Docket Number:	15-RETI-02
Project Title:	Renewable Energy Transmission Initiative 2.0
TN #:	215205
Document Title:	Conservation Organizations' comments on RETI 2.0 Plenary Report
Description:	Conservation Organizations are: The Nature Conservancy, Defenders of Wildlife, Sierra Club, Natural Resources Defense Council, and Audubon California
Filer:	System
Organization:	Conservation Organizations/Erica Brand
Submitter Role:	Public
Submission Date:	1/10/2017 7:58:23 AM
Docketed Date:	1/10/2017

Conservation Organizations' comments on RETI 2.0 Plenary Report

RE: Comments to Renewable Energy Transmission Initiative (RETI) 2.0 Plenary Report –
Public Review Draft

FIGURE 2
Biological Conservation Framework Map with BLM DRECP LUPA Conservation Designations

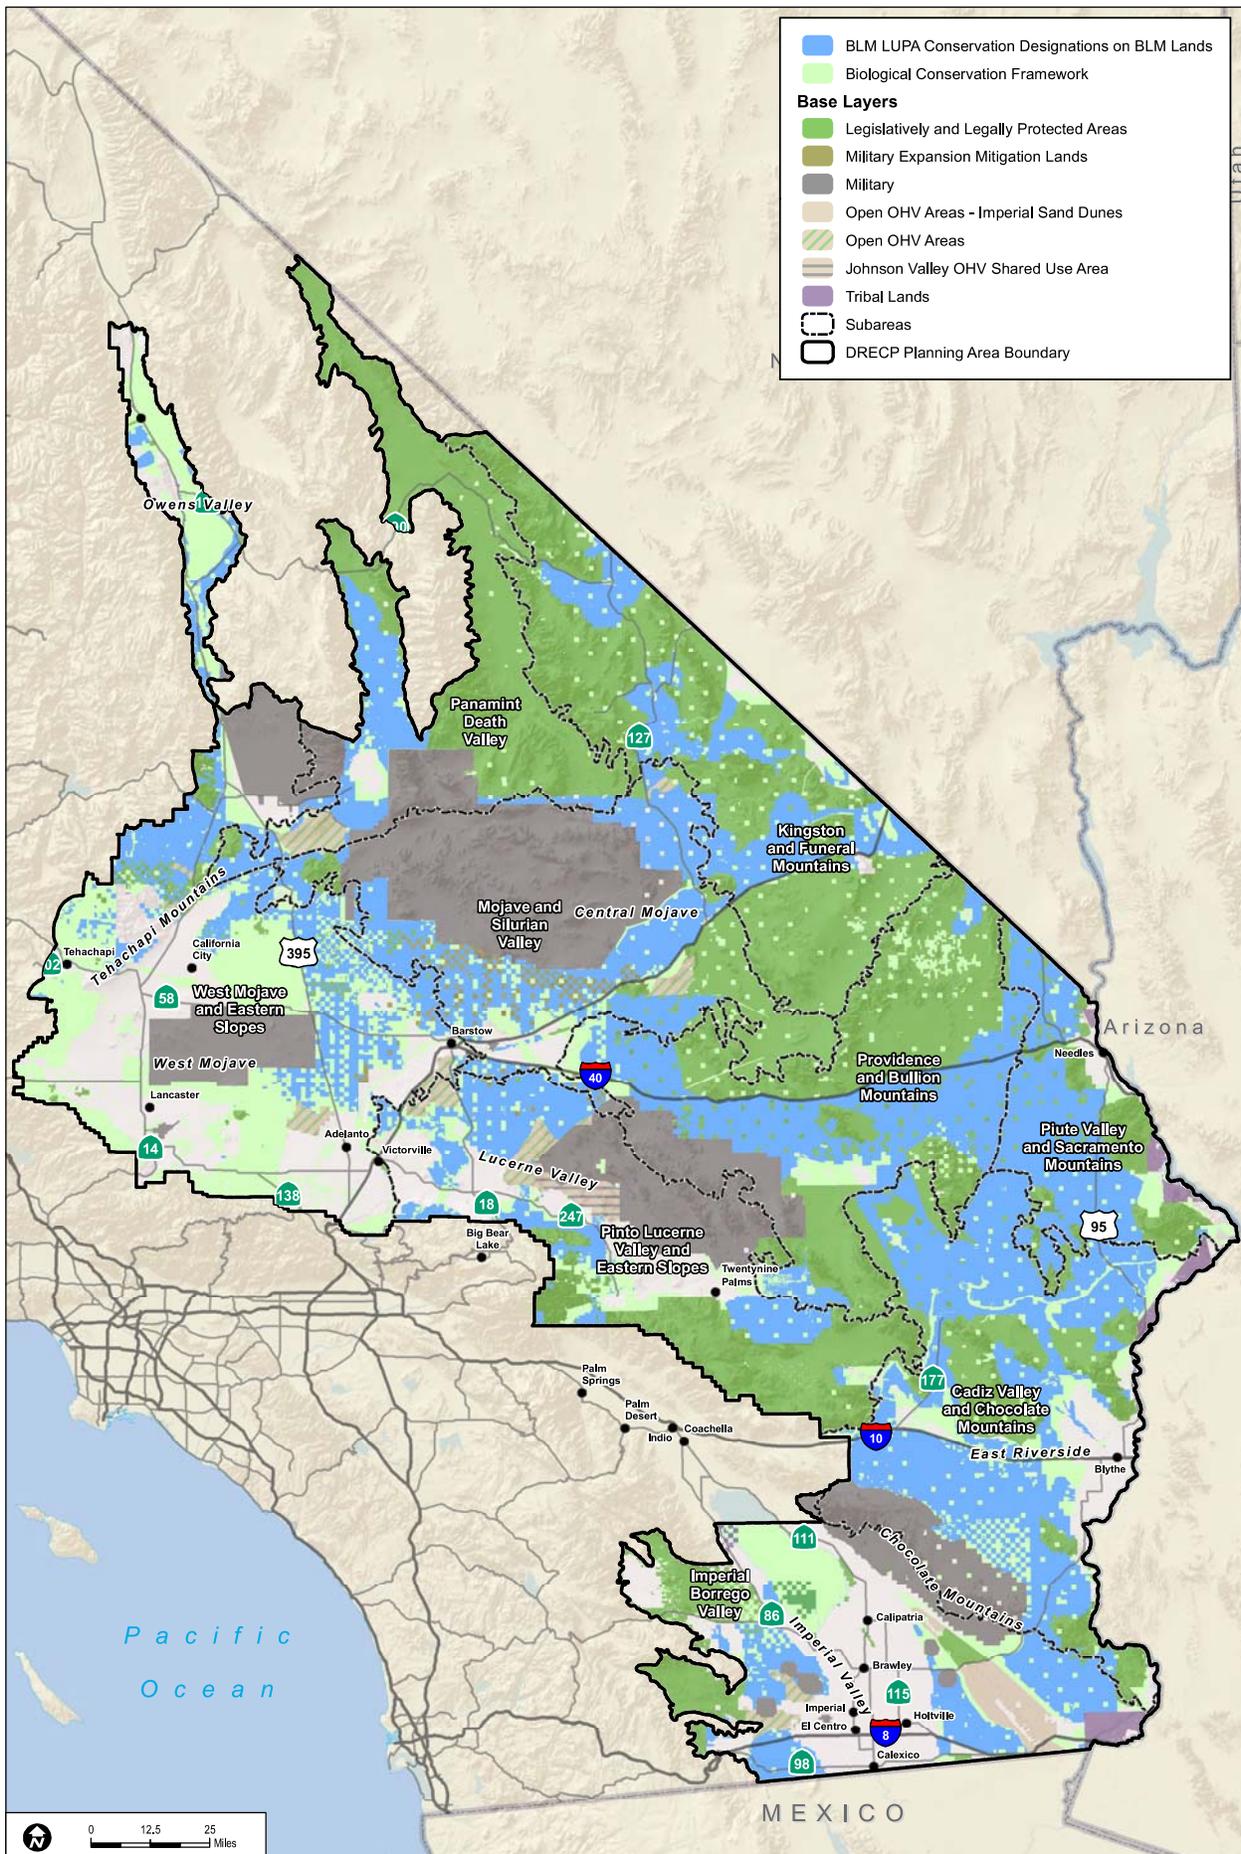
The RETI 2.0 Plenary Report and Appendix A should account for potential additional constraints on renewable energy and transmission project development due to the Biological Conservation Framework, especially in TAFAs that include lands located within the Owens Valley, Indian Wells Valley, eastern slope of the Sierra Nevada and Tehachapi Mountains, and Antelope Valley. A map of the Biological Conservation Framework Lands is attached. The Plenary Report must be updated to include the Biological Conservation Framework.

The main issue with this TAFE is the 5-year moratorium on any renewable energy development within the DFA north of Kramer Junction, or alternatively until such a time as Kern County and San Bernardino County finalizes their updates to their general plans that will specify how interspersed private lands will be zoned for Mohave ground squirrel conservation and what private lands will be available for renewable energy development, and the California Department of Fish and Wildlife (CDFW) finalizes its Mohave ground squirrel conservation strategy which will consider all lands within the range of the species including this DFA. In December 2016 the DRECP agencies released the Biological Conservation Framework which identifies lands, both federal and private, considered essential to meet biological resources goals and objectives. This framework is considered a key document to be used by local agencies in preparing their renewable energy and conservation elements to their general plans. All lands within the DFA north of Kramer are included in the Biological Conservation Framework lands, and were included specifically for the conservation of the Mohave ground squirrel.

Biological Conservation Framework lands overlap large areas of the Victorville-Barstow TAFE, potentially imposing future constraints on renewable energy development.
